From: Griffin, Tim (Contractor)
Sent: 09 February 2026 15:43
To: Altman, Rebecca
Cc: Oliveira, Marta (Contractor); Dyer, Tim; Ellison, Mark
Subject: Re: RM/25/100614 - OHH The Folds - Landscape comments

From: Griffin, Tim (Contractor)
Sent: 07 February 2026 19:42
To: Altman, Rebecca <rebecca.altman@eastleigh.gov.uk>
Cc: Oliveira, Marta (Contractor) <Marta.Oliveira.Contractor@eastleigh.gov.uk>; Dyer, Tim <Tim.Dyer@eastleigh.gov.uk>; Ellison, Mark <Mark.Ellison@eastleigh.gov.uk>
Subject: RM/25/100614 - OHH The Folds - Landscape comments

I have been asked to provide landscape comments on this reserved matters application.

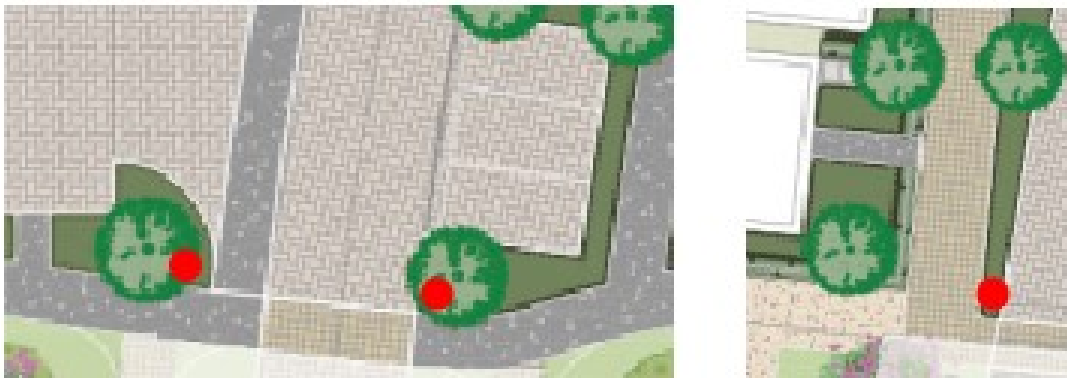
The site relies on the surrounding existing vegetation to improve the setting of the development. It is good to note that tree loss is kept to a minimum, although some significant lengths of field boundary hedges will be removed. The planting scheme should ensure that significant stretches of new native hedging are included to balance these losses.

Typical snapshot for sample area indicating where trees require specialist pits:

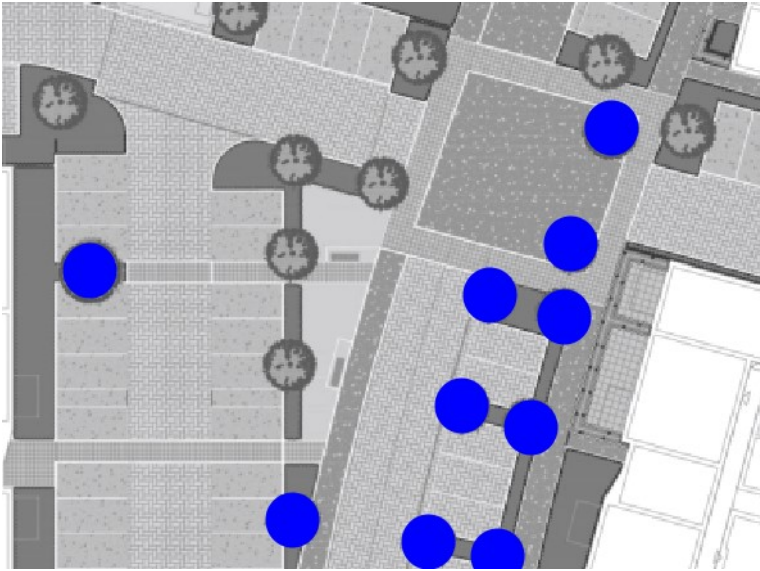
It is critical that the tree planting can be delivered. This will require provision of specialist Silva cell pits where the trees are planted in narrow strips surrounded by hard surfacing. The location of all trees requiring specialist pits should be clearly indicated on the landscape masterplan using a symbol/colour that won't be missed.

These pits are expensive, so must be allowed for in early costings of the scheme. Omission of these pits will result in these trees failing.

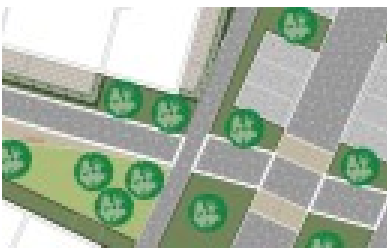
e/ **Central Greenway & Central Green** - these linked landscaped spaces are well designed and a key strength of the design. The structure tree planting is well considered and will provide connected GI. The tree planting enclosing the Central Green is an attractive feature, although a little further work is required to fine tune the layout of these trees for best effect.

I am not clear why the main central cycleway dog-legged slightly at this point rather than running straight on a continuous line?
